415 Cumberland Avenue

415 Cumberland Avenue - Final Traffic Comments

Subject: Application ID: 2018-011

PEZ 2018-011: Building Conversion, 415 Cumberland Avenue

415CumberlandAve_CurbRampProposed_Sept22-16 (1).pdf
652K

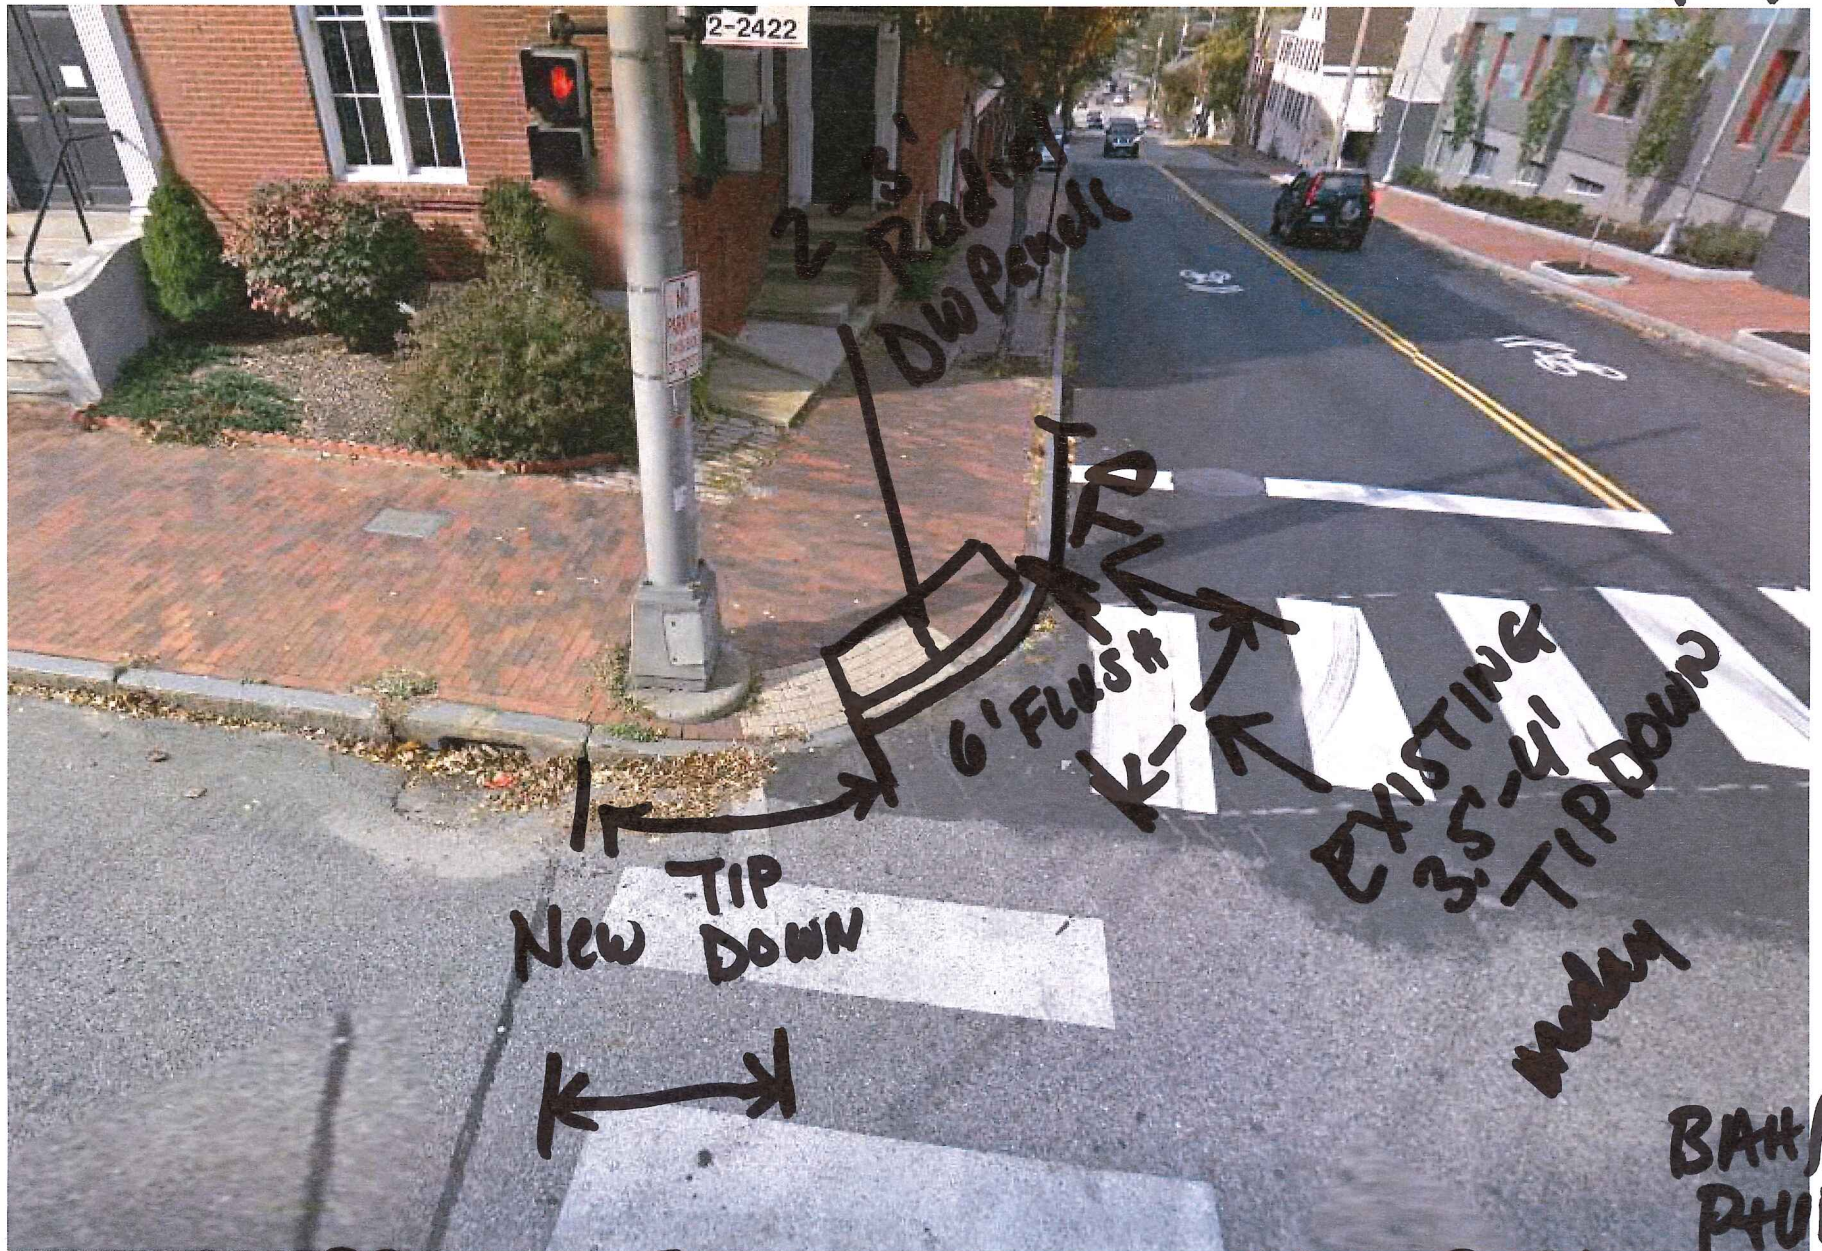
- the curb ramp is to be updated to achieve full ADA-compliance and meet existing Technical Standards - I've attached the curb ramp configuration provided to the previous applicant's project team for this location - the current standard for the detectable warning panel within the curb ramp is cast iron with a 4" concrete border and is available from DPW if needed

WILL PROVIDE BETTER ALIGNMENT TO BOTH RECEIVING CROSSWALKS
